SERVICE BULLETIN

APPLICABILITY: 2015-2016MY Impreza 4-Door
2015-2018MY WRX

NUMBER: 12-241-18

SUBJECT: Trunk Lid Lock Assembly Interchangeability Information

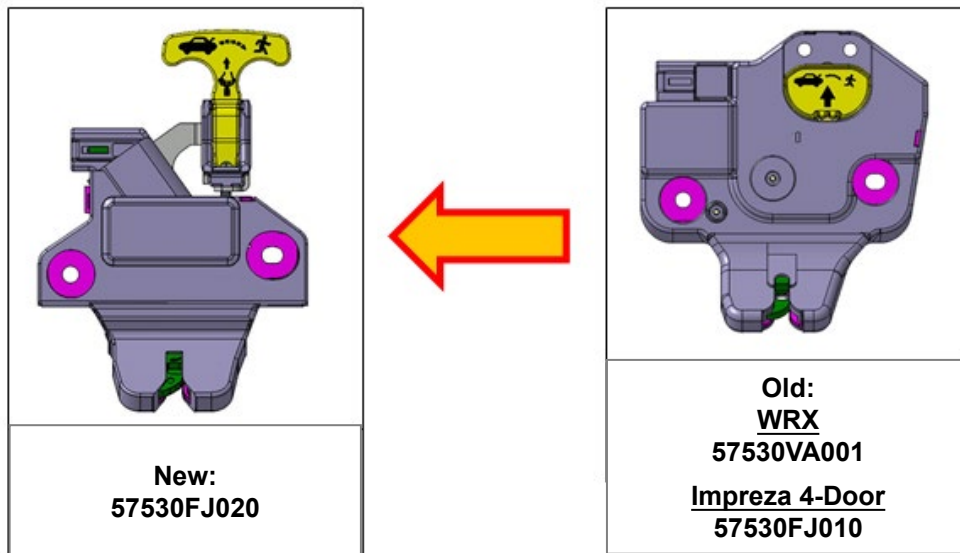
This bulletin announces a change made to the trunk lid lock (latch) assembly. The purpose of this change is to improve parts integration (or “commonality”) between models. This change is not intended to address any specific customer concern. The Owner’s Manuals are currently being revised with the new part images.

The new “T-Handle” style trunk lid lock was incorporated into production starting with VIN **F9828714**.

The new “LOCK ASSEMBLY-TRUNK LID” part number is **57530FJ020**.
